APPLICATION NO.	FILING DATE	FIRST NAMED INVENTOR	ATTORNEY DOCKET NO.	CONFIRMATION NO.
09/779,788	02/07/2001	Behrooz Rezvani	VELCP009C	7770
28436	7590	06/08/2005	EXAMINER	
IP CREATORS P. O. BOX 2789 CUPERTINO, CA 95015			DEPPE, BETSY LEE	
			ART UNIT	PAPER NUMBER
			2637

Office Action Summary

DETAILED ACTION

FIG. 7B

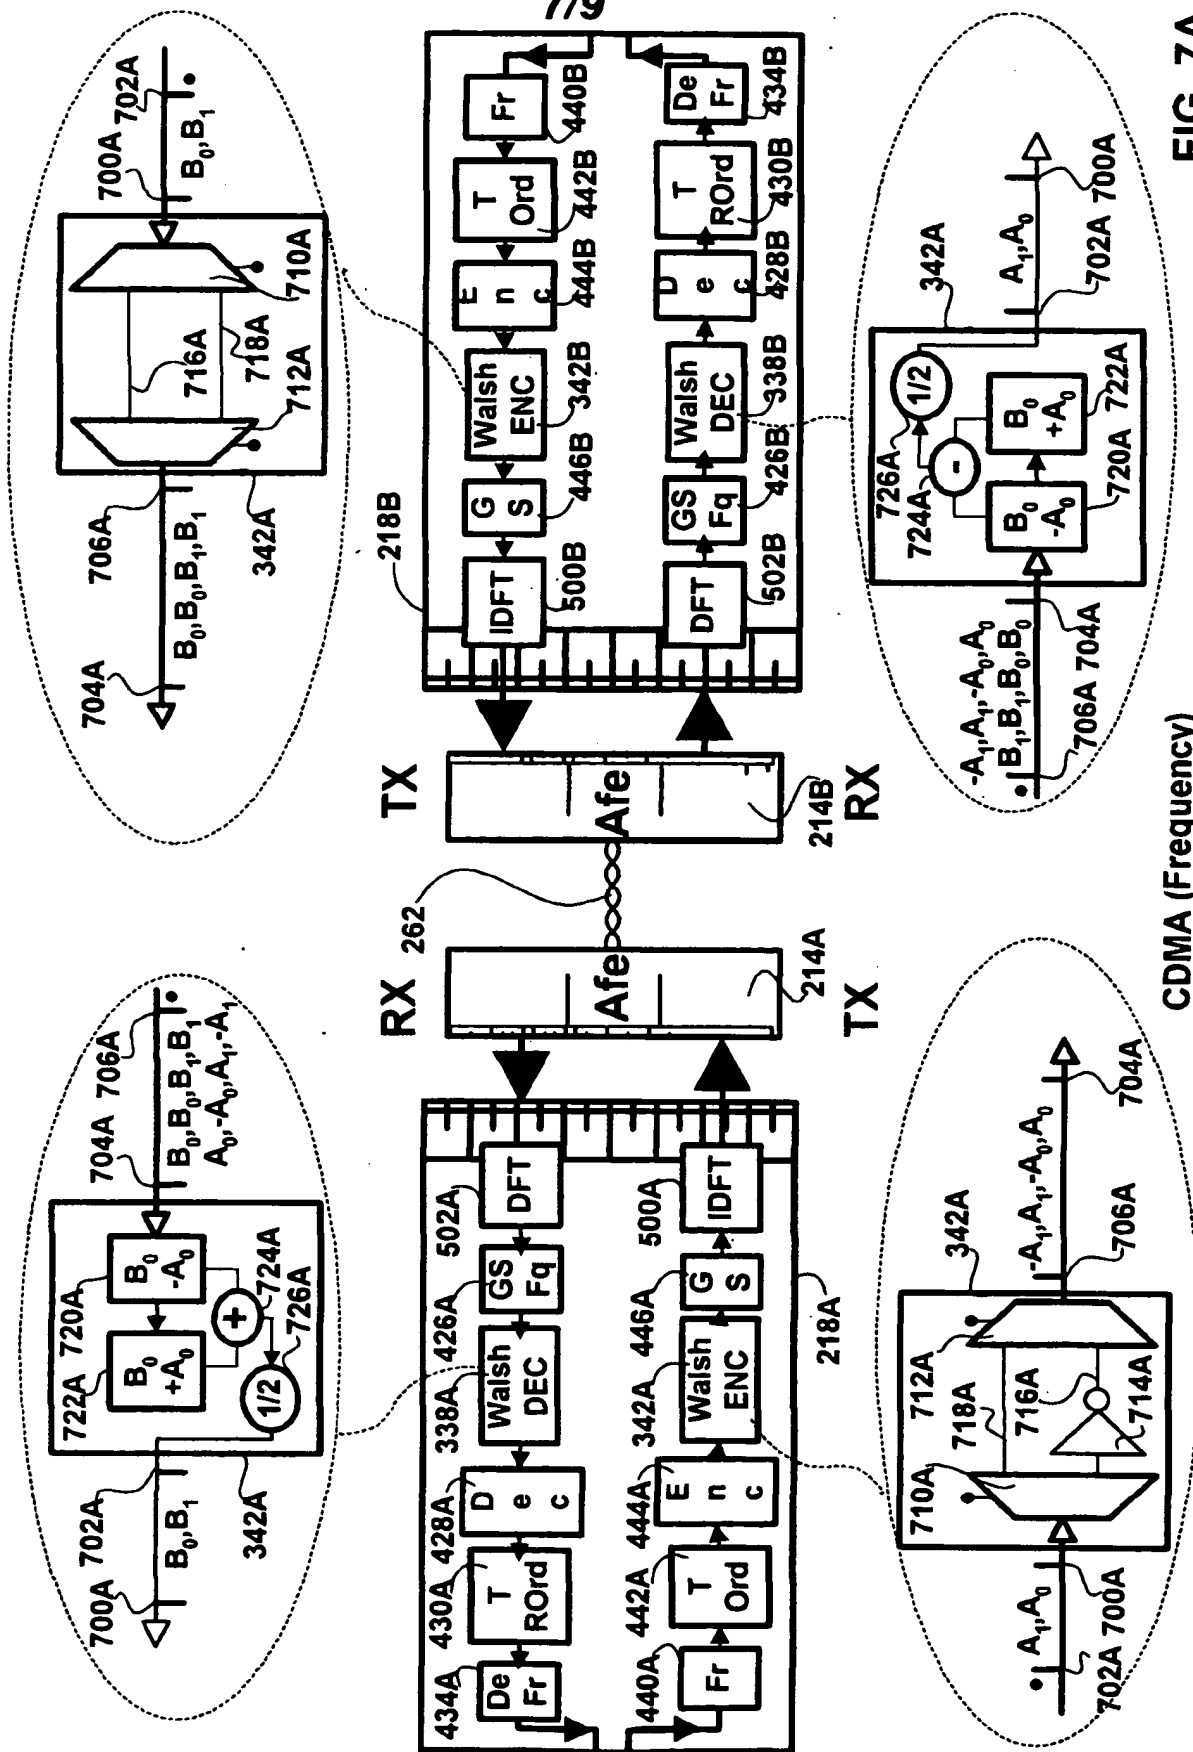
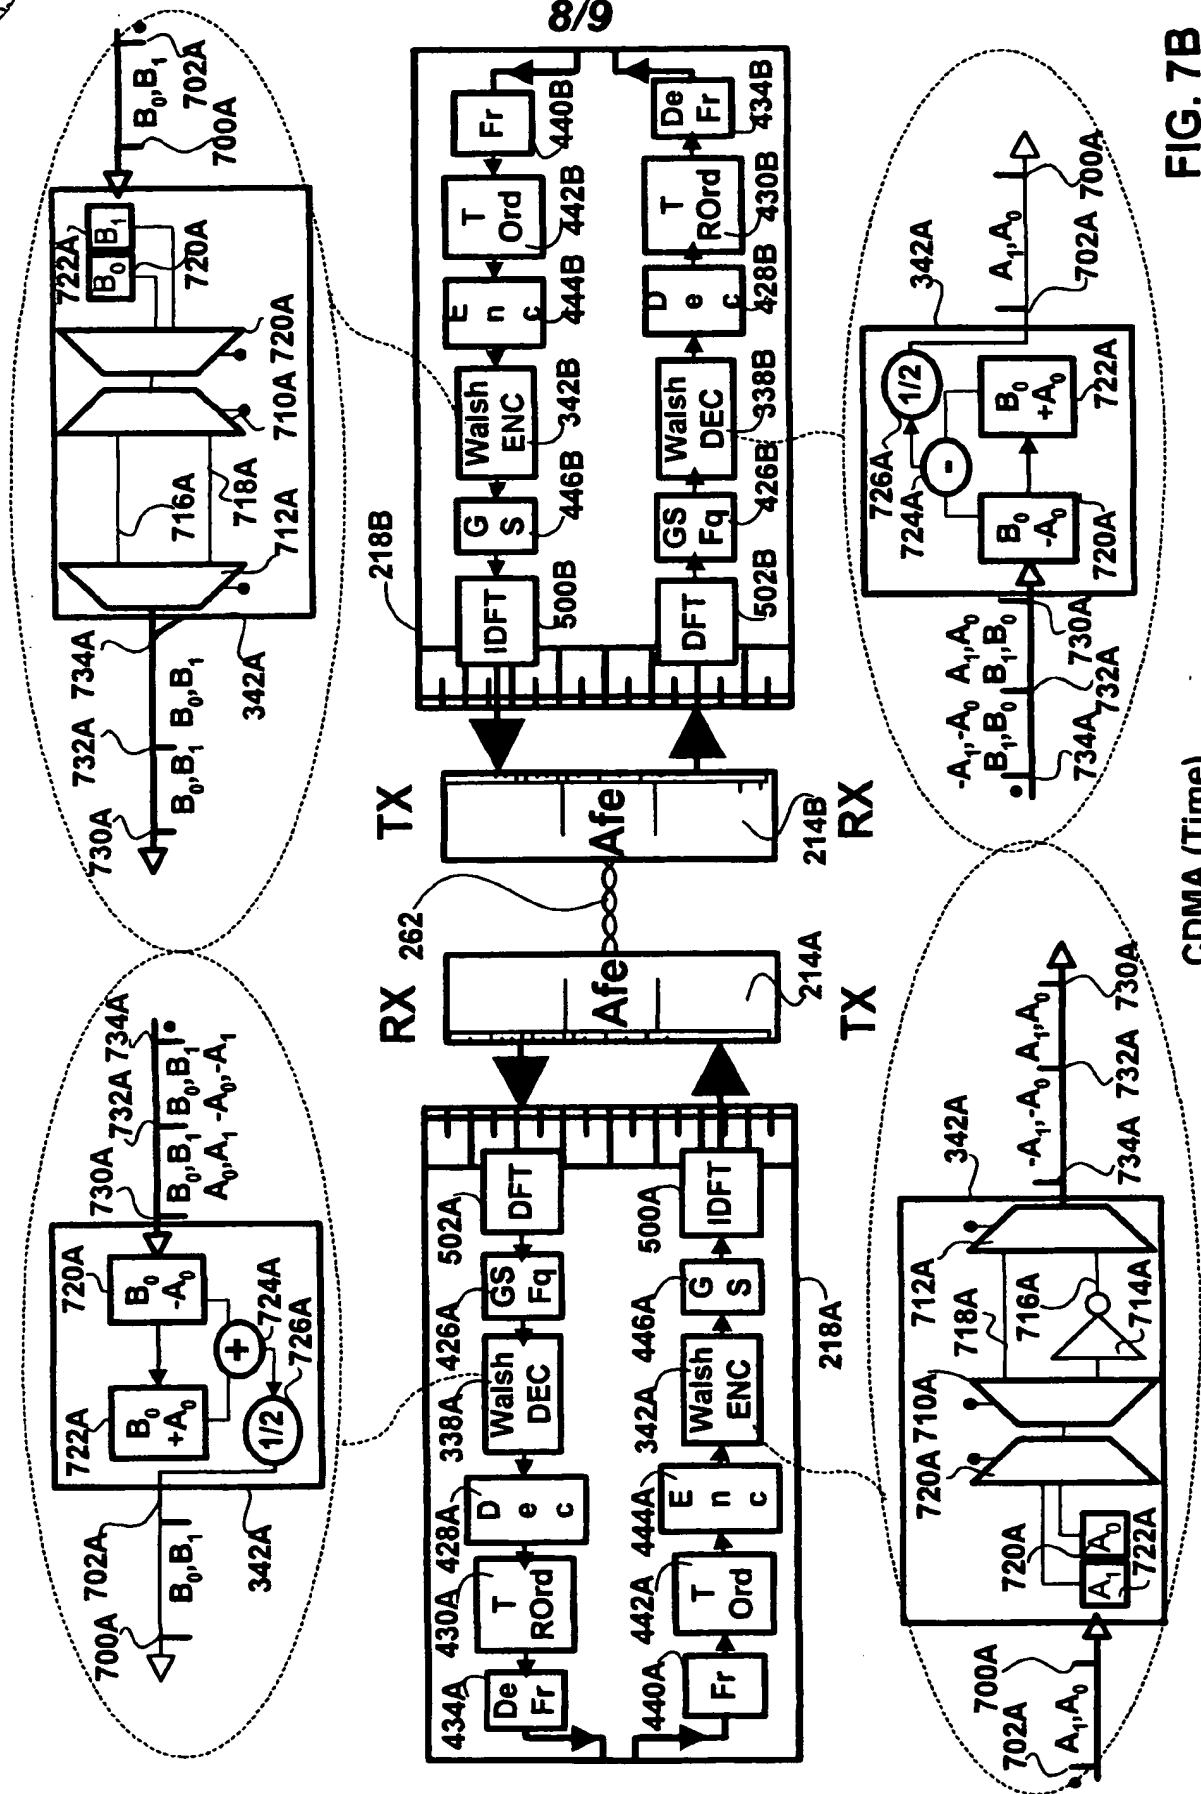
1. The drawings were received on January 24, 2005. These drawings are accepted.
2. The drawings are objected to as failing to comply with 37 CFR 1.84(p)(4) because reference character "724A" has been used to designate both an adder and a subtractor in Figures 7A and 7B. Since page 16, line 24, refers to "724A" as "summers," it appears that the subtractor in Figures 7A and 7B should be changed to an adder.

Corrected drawing sheets in compliance with 37 CFR 1.121(d) are required in reply to the Office action to avoid abandonment of the application. Any amended replacement drawing sheet should include all of the figures appearing on the immediate prior version of the sheet, even if only one figure is being amended. Each drawing sheet submitted after the filing date of an application must be labeled in the top margin as either "Replacement Sheet" or "New Sheet" pursuant to 37 CFR 1.121(d). If the changes are not accepted by the examiner, the applicant will be notified and informed of any required corrective action in the next Office action. The objection to the drawings will not be held in abeyance.
